SUBJECT: Forwards update to util revised response to IE Bulletin
 84-03, re final design of plant refueling cavity water seal.
 Seal provides redundant passive safety-related means of
 limiting refueling pool leakage.

Re: Turkey Point Units 3 and 4
Docket Nos. 50-250 and 50-251
IE Bulletin 84-03 (Revised Response)

AMENDED RESPONSE TO IE BULLETIN 84-03
"REFUELING CAVITY WATER SEAL"

TURKEY POINT UNITS 3&4
REACTOR CAVITY SEAL
REVISED DESIGN
FIGURE 2

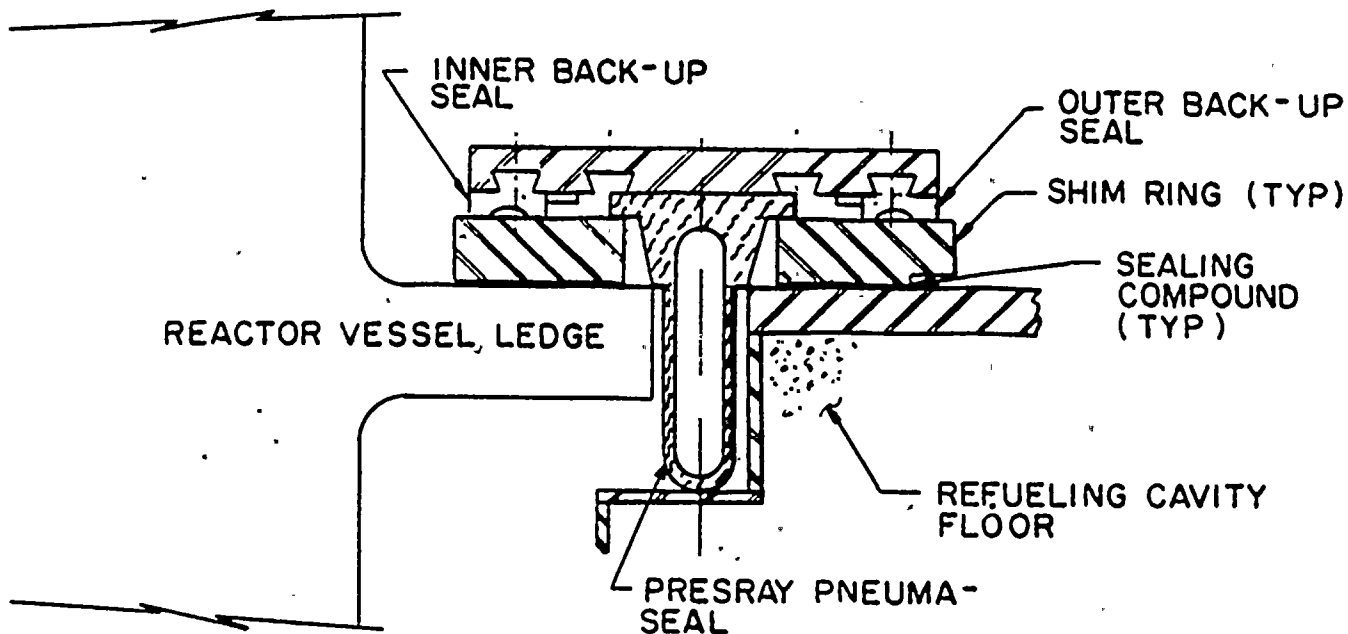
The revised design is shown in Figure 2. A new seal ring plate was fabricated from stainless steel to replace the original carbon steel seal ring plate. The new stainless steel plate was analyzed and stiffener members added to reduce stresses and deflection of the plate during lifting and while in place.

Measurements of the existing condition of the reactor cavity were taken and compression seals were designed and fabricated to provide a leaktight seal with the expected tolerance of the installed assembly. Two compression seals are provided on each side of the 2" annular gap comprising the reactor cavity and are affixed to the seal ring plate by dovetail retainers molded into the seal (which fit into dovetail grooves machined into the bottom of the seal ring plate.) The compression seals perform the safety function by providing a redundant passive means of limiting high volume losses (greater than 50 gpm) from the refueling pool. The acceptable leakage rate of 50 gpm is based on: a) The ability of the two 75 gpm reactor sump pumps to transfer this flowrate to the waste hold-up tank or refueling water storage tank; and, b) The acceptable rate of falling reactor cavity/spent fuel pit levels of less than two inches per hour allows for adequate operator response times to take corrective action. Although the maximum acceptable leakage rate has been set at 50 gpm, actual leakage past the seals is expected to be near zero based on previous experience with similar seals and based upon experimental and in situ testing.

Preload is applied to the compression seals via compression arms that act on the top of the seal ring plate. The compression arms are torqued to a predetermined value that will deflect the compression seals into their operating range around their entire circumference.

An analysis was performed on the compression seals to determine margin of safety against failure. Considering the preload obtained from the compression arms and hydrostatic forces, the compression seals have a margin of safety of at least 4.68 against failure. In addition, the compression seals were tested by the vendor at up to 30 psig equivalent static water pressure, a factor of safety of at least 2.77, without leakage.

An inflatable seal is also provided to perform the non-safety related function of minimizing leakage in accordance with ALARA considerations. The inflatable seal is also affixed to the seal ring plate by dovetail retainers molded onto the seal which fit into dovetail grooves machined into the bottom of the plate. When the plate is installed, the inflatable seal hangs into the 2" annular gap between the reactor vessel flange and refueling cavity ledge. When inflated to its operating pressure of 30 to 35 psig, the inflatable seal expands to form a seal against the wall of the reactor cavity and the reactor vessel flange to stop any leakage that may have passed the compression seals.

**TURKEY POINT UNIT 4
REACTOR CAVITY SEAL
INTERIM DESIGN
FIGURE 1
FLORIDA POWER & LIGHT COMPANY
DATE 5/22/87
SCALE**

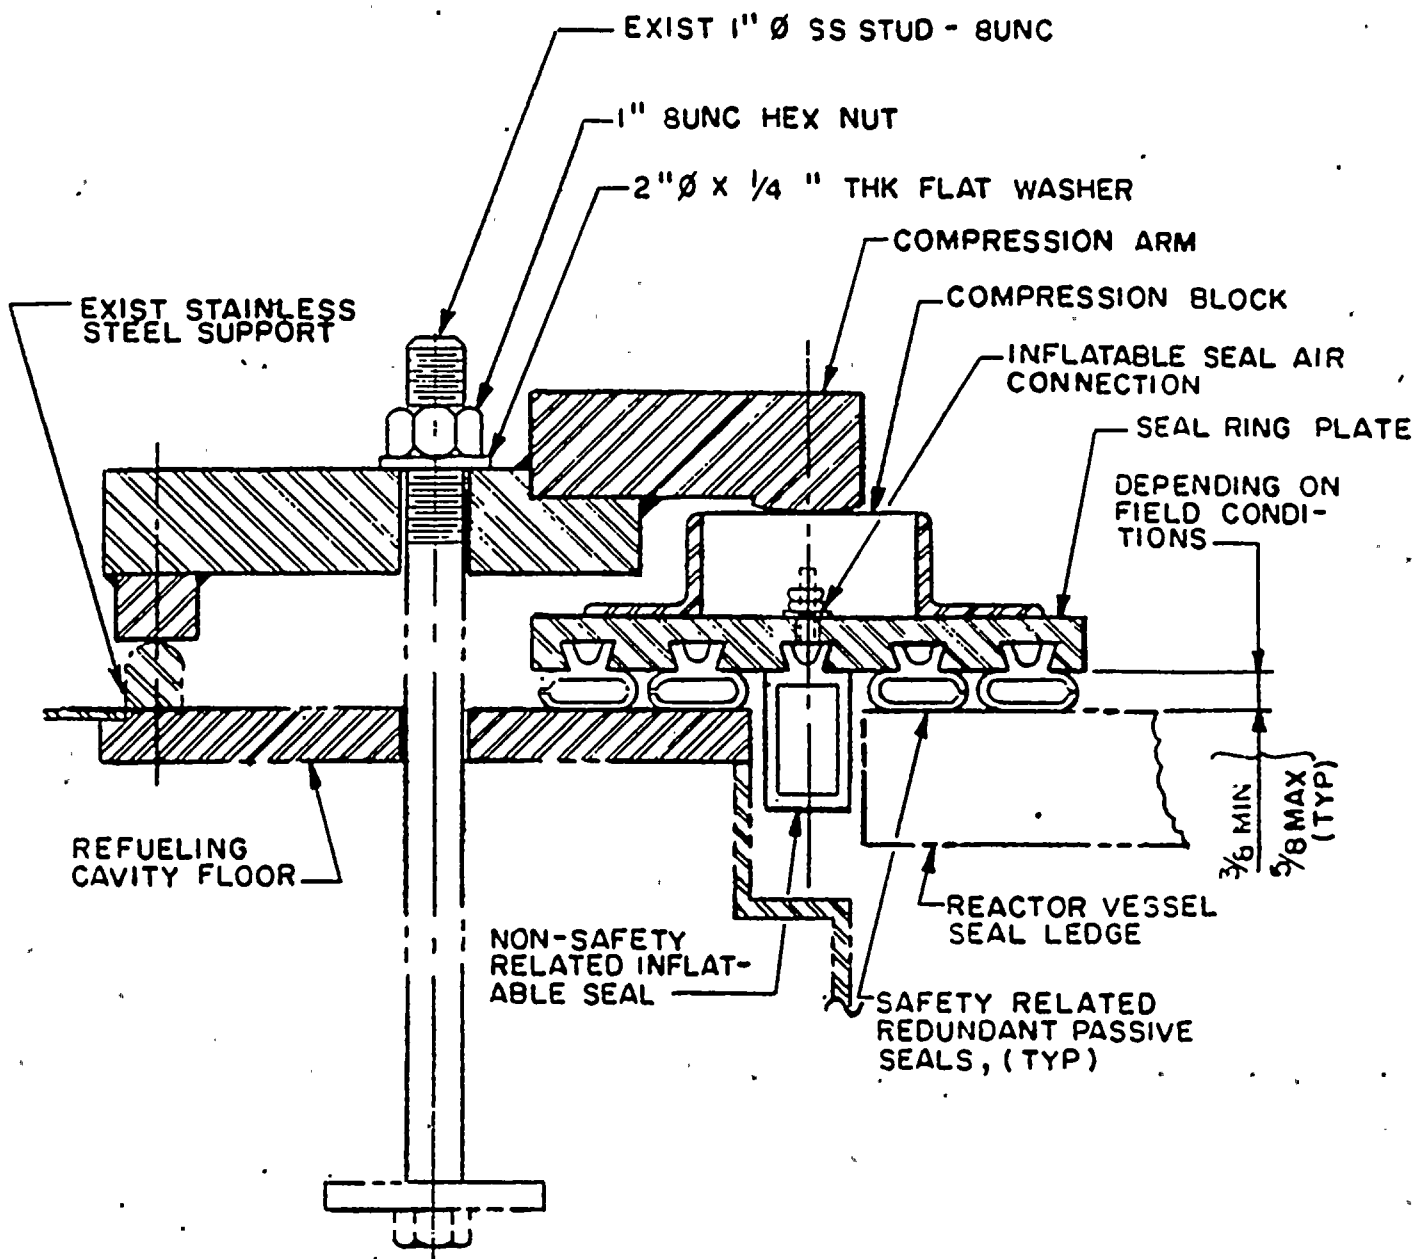
During the implementation of PC/M 85-94 in January 1986, a discrepant condition was discovered that required an interim design to be implemented. The interim design which was discussed in a previous Amended Response to IE Bulletin 84-03 submitted in March, 1986 installed shim rings to provide seating surfaces for the inflatable seal as well as the back-up seals. The interim design is shown in Figure 1.

TURKEY POINT UNITS 3 & 4
REACTOR CAVITY SEAL
SEAL PRESSURIZATION SYSTEM
FIGURE 3
FLORIDA POWER & LIGHT COMPANY
DATE 5/22/87
SCALE

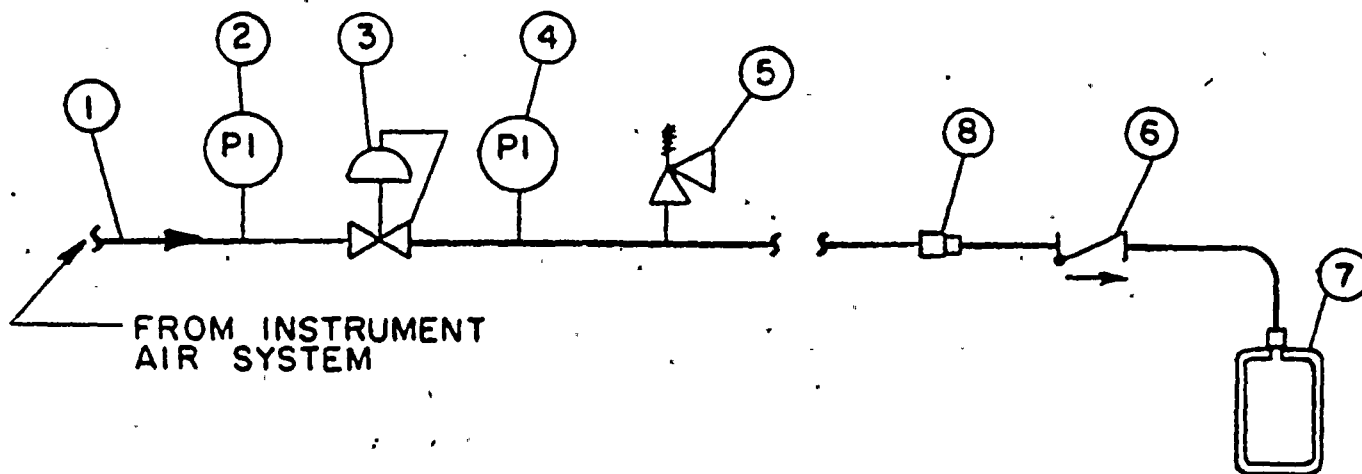
The inflatable seal is pressurized using plant instrument air. The seal pressurization system is shown in Figure 3. The system includes a pressure regulator to control air pressure to the seal, local pressure indication upstream and downstream of the regulator, a relief valve sized to handle flowrates that will be experienced in the event of a regulator failure and a check valve to maintain the seal in the inflated condition should air supply pressure be lost. A failure modes analysis was performed on the inflatable seal and concluded that no potential failure mode of the inflatable seal will have an adverse effect on the safety related compression seals.
